STAFF REPORT  
KETCHUM PLANNING AND ZONING COMMISSION  
MEETING OF APRIL 23, 2024

**PROJECT:** Warm Springs Townhomes

**FILE NUMBER:** P23-103

**APPLICATION:** Pre-Application Design Review

# 02.0 \ PROJECT NARRATIVE: Maximum Building Height

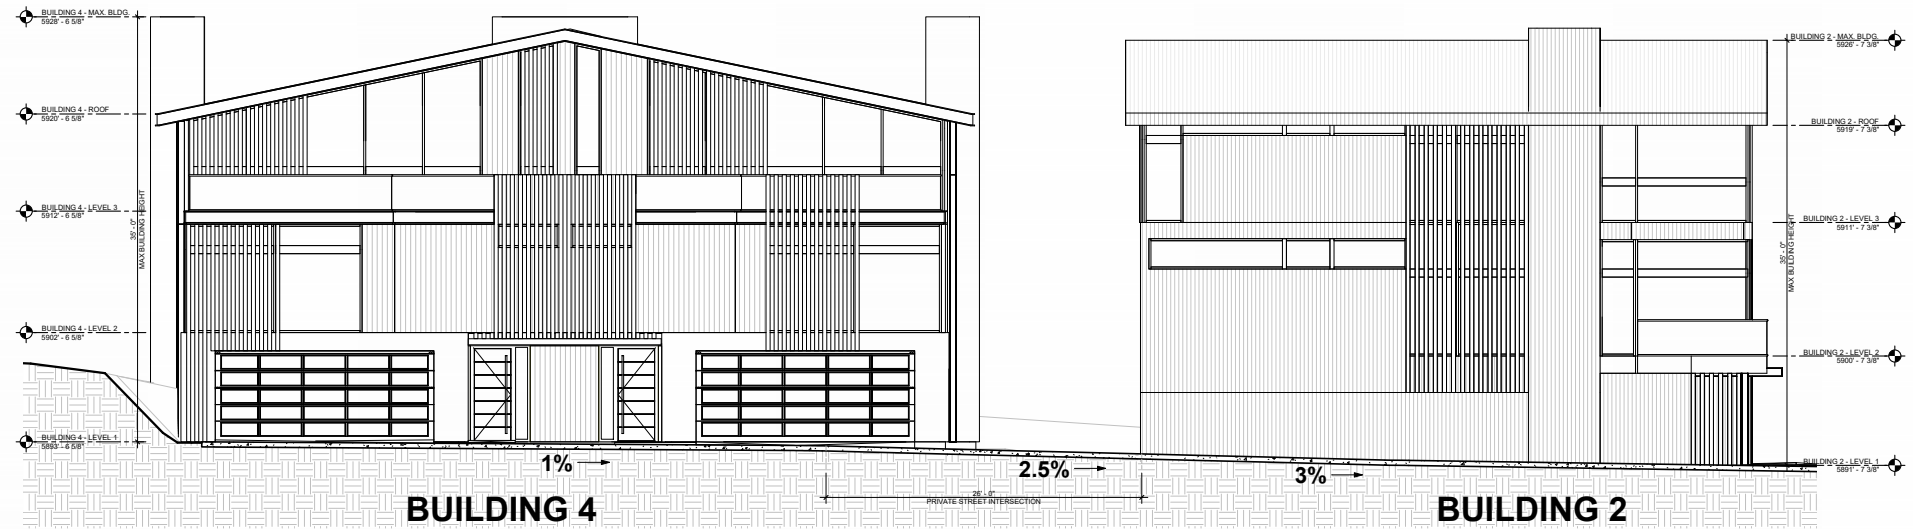
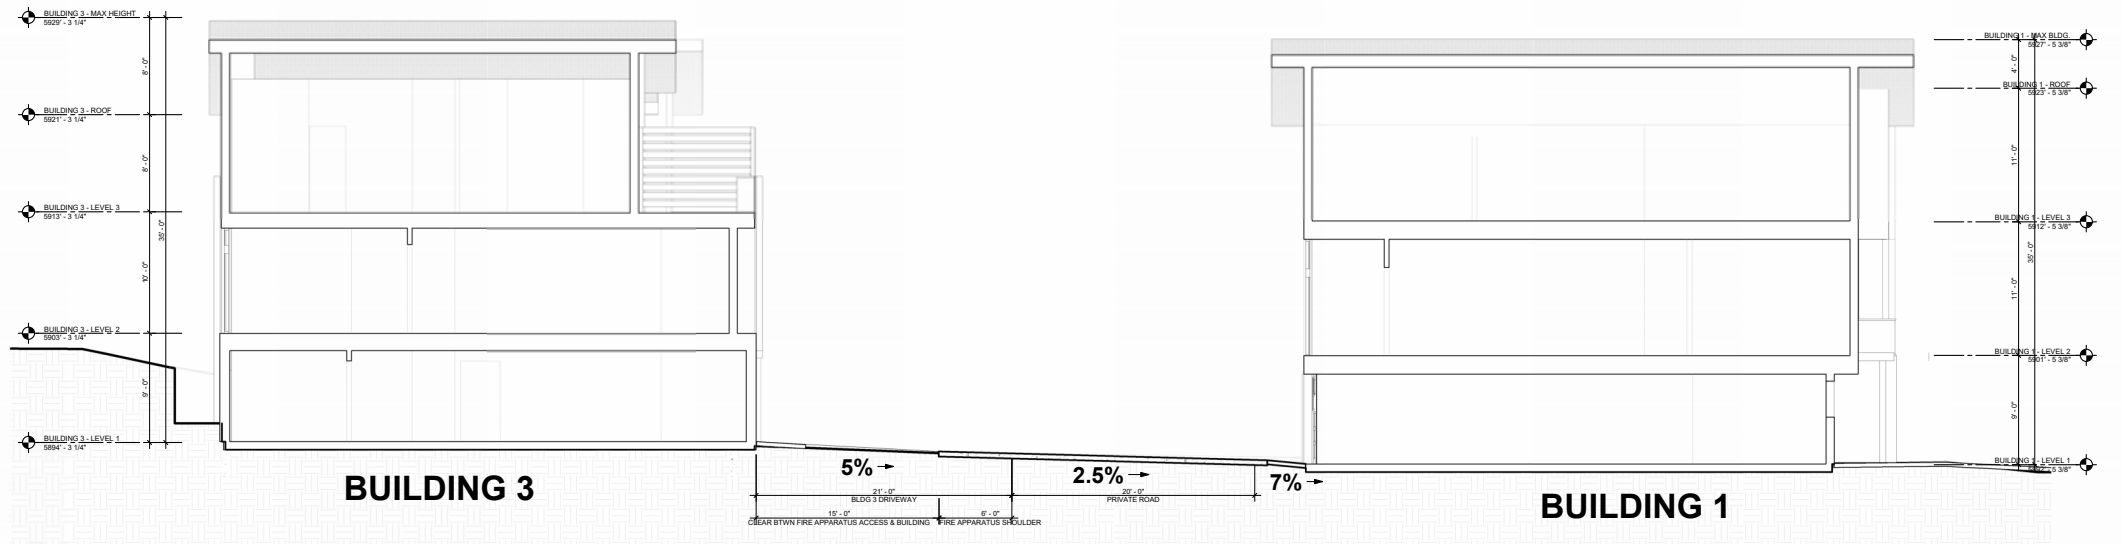
<input checked="" type="checkbox"/>	<input type="checkbox"/>	<input type="checkbox"/>	<b>17.12.030</b>	<b>Building Height</b>
			<b>Staff Comments</b>	<p><b>Permitted:</b> 35 feet</p> <p><b>Proposed:</b> 35 feet (see page 12 of the plans)</p>
<input checked="" type="checkbox"/>	<input type="checkbox"/>	<input type="checkbox"/>	<b>17.125.030H</b>	<b>Driveway</b>
			<b>Staff Comments</b>	<p><b>Permitted:</b> Not less than 12 feet and not more than 35% of street frontage or 30 feet (whichever is less) unless otherwise approved by the City Engineer.</p> <p><b>Proposed:</b> Private roads curb cuts are not subject to driveway width requirements. Building 2 has driveways directly onto Ritchie Dr which are 12 feet in width.</p>
<input checked="" type="checkbox"/>	<input type="checkbox"/>	<input type="checkbox"/>	<b>17.125.040</b>	<b>Parking Spaces</b>
			<b>Staff Comments</b>	<p><b>Required:</b>  1 space for units between 751 and 2,000 SF  2 spaces for units 2,001 SF and greater</p> <p><b>Proposed: (per Page 11)</b>  12 units total  11 units over 2,001 SF = 22 parking spaces required  1 unit between 751 and 2,000 SF = 1 parking space required  Total spaces required: 23  Total Spaces provided: 23  *Note: There are errors in the Project Matrix chart about the assignment of parking spaces. However, the drawings are correct and meet the requirements.</p>

7. **Discrepancies** noted on the city of Ketchum planning and zoning document concerning parking spaces, (21 vs 22) building height (33' vs 35") and setback. (10' vs 11'8")

# 02.0 \ PROJECT NARRATIVE: Lot Setbacks

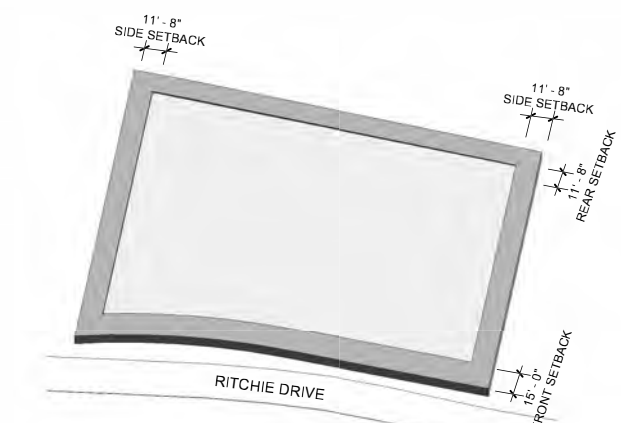
5. **Set back zone has retaining walls being built in a zone that does not allow construction.** The developer claims 11'8" setback then builds out from the units several retaining walls. The set back zone must be free of structures. The retaining walls are over 30" high. The set back should be increased to whatever the depth of the retaining wall encroaches into the setback zone – moving the building 4 feet south to put the edge of the retaining wall at 11' 8" from the property line and the building 15'8 from the property line.

# 02.0 \ PROJECT NARRATIVE: FAR

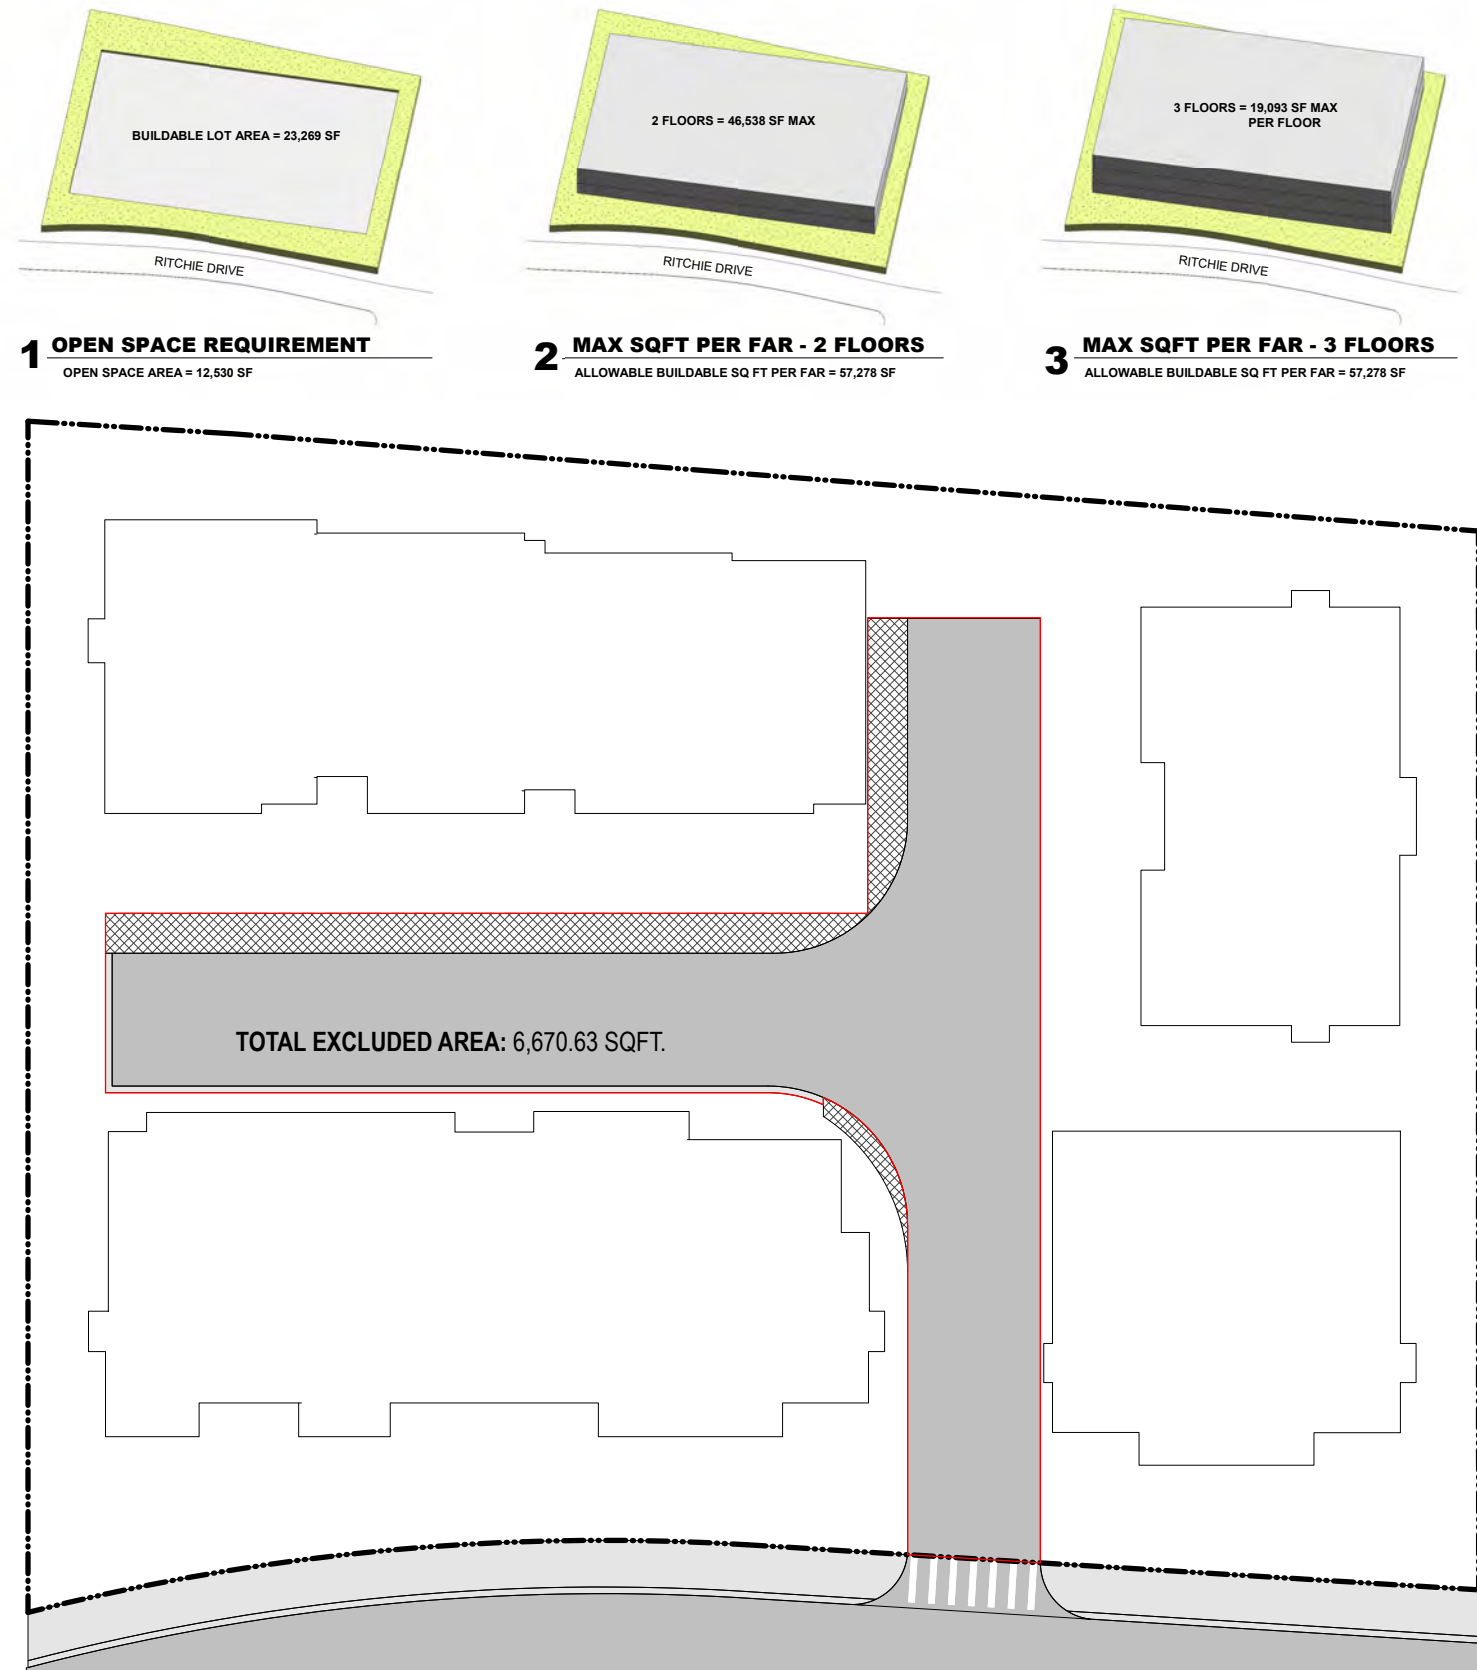
As noted above, the applicant is utilizing the FAR density bonus program. The base FAR permitted in the T-3000 zone district is 0.5, but can be increased to 1.6 with community housing mitigation. The proposed development has an FAR of 1.36 as shown on Page 14 of the application materials. The applicant has elected to pay a fee in-lieu of community housing for their mitigation and will be required to pay approximately \$2.3 million in housing in-lieu fees. The detailed calculation of the fee can be found in Attachment 2.

# 02.0 \ PROJECT NARRATIVE: Open Space Requirement

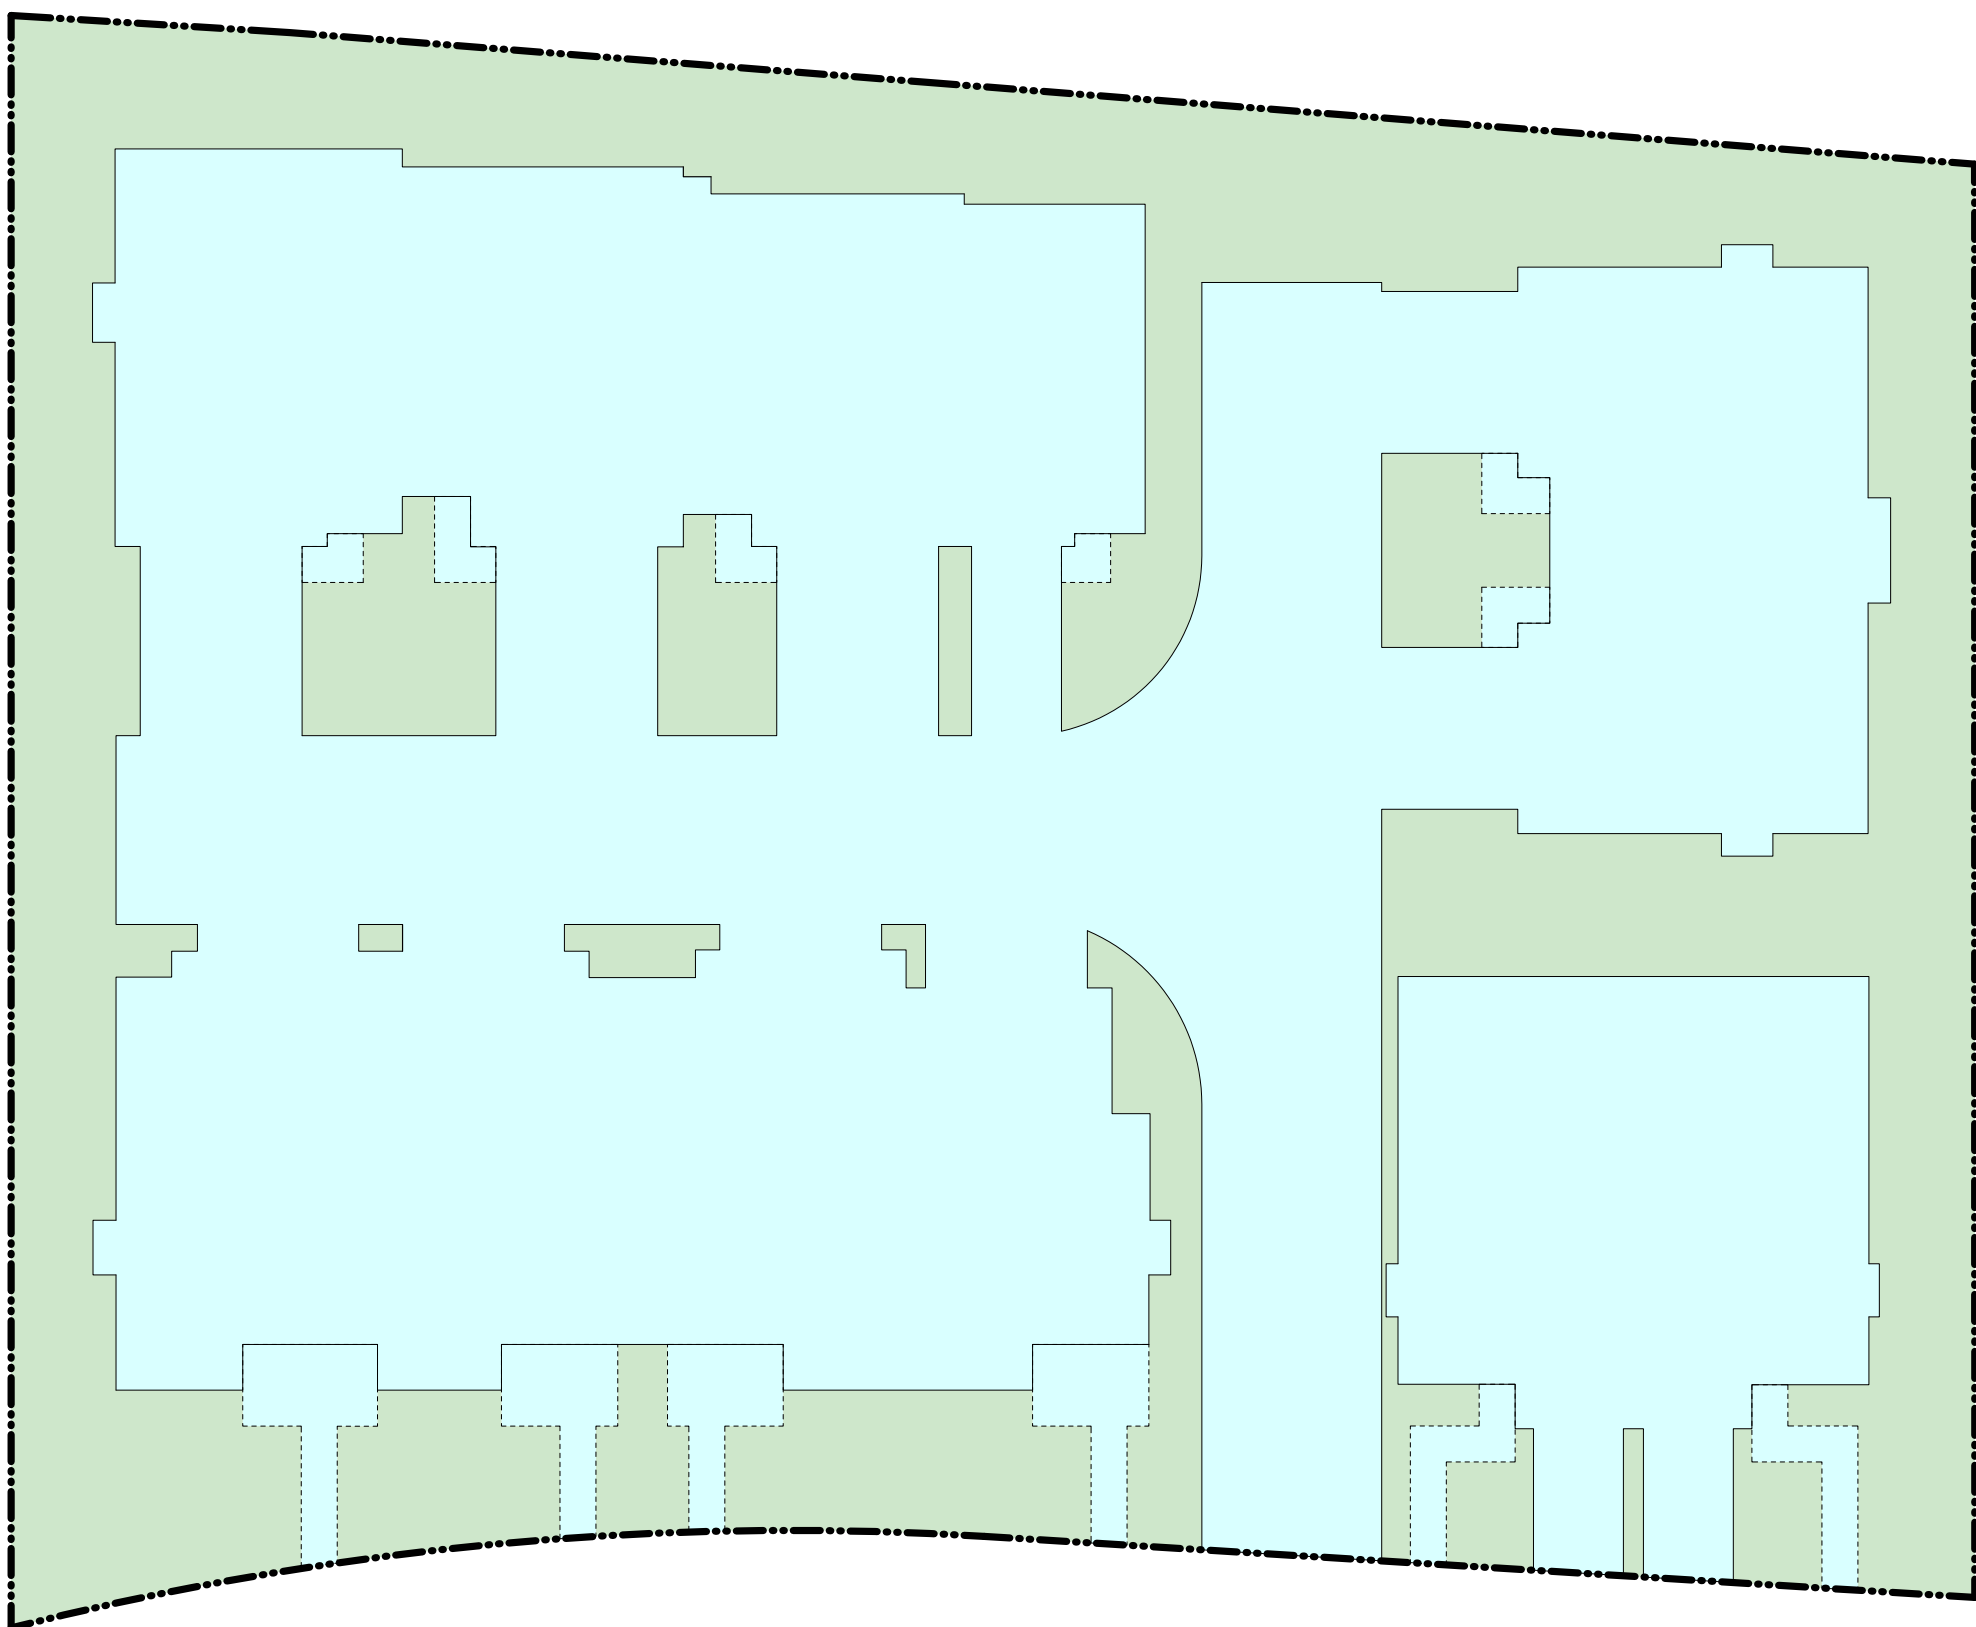
<input checked="" type="checkbox"/>	<input type="checkbox"/>	<input type="checkbox"/>	<b>17.12.030</b>	<b>Open Site Area</b>
			<b>Staff Comments</b>	<p><b>Required:</b> 35% - A maximum of five percent open site area may be used for private decks or patios and walkways subject to design review approval.</p> <p><b>Proposed: Per Page 16</b></p>

<p>Total Lot area: 35,799 SF</p> <p>Total area of Buildings, driveways, and private street: 22,785 SF</p> <p>35,799 SF – 22,785 SF = 13,041 SF</p> <p>13,041 SF + 636 SF (private patios and walkways) = 13,677 SF</p> <p>13,677 SF/35,799 SF = 38% open space area</p>
<input checked="" type="checkbox"/>	<input type="checkbox"/>	<input type="checkbox"/>	<b>17.124.180</b>	<b>Minimum Residential Density</b>
			<b>Staff Comments</b>	<p><b>Required:</b> 4 residential units per 10,000 SF of lot area</p> <p>Total Lot Area: 29, 128 SF / 10,000 SF = 2.9</p> <p>2.9 x 4 units = 12 units</p> <p><b>Proposed:</b> 12 Units</p>

4. **Open space calculation – does not account for the retaining walled area as non-open space.** There needs to be 12,529 of open space the proposed plan does not appear to be compliant. The plans lack dimensional details to fully verify the open space calculation.
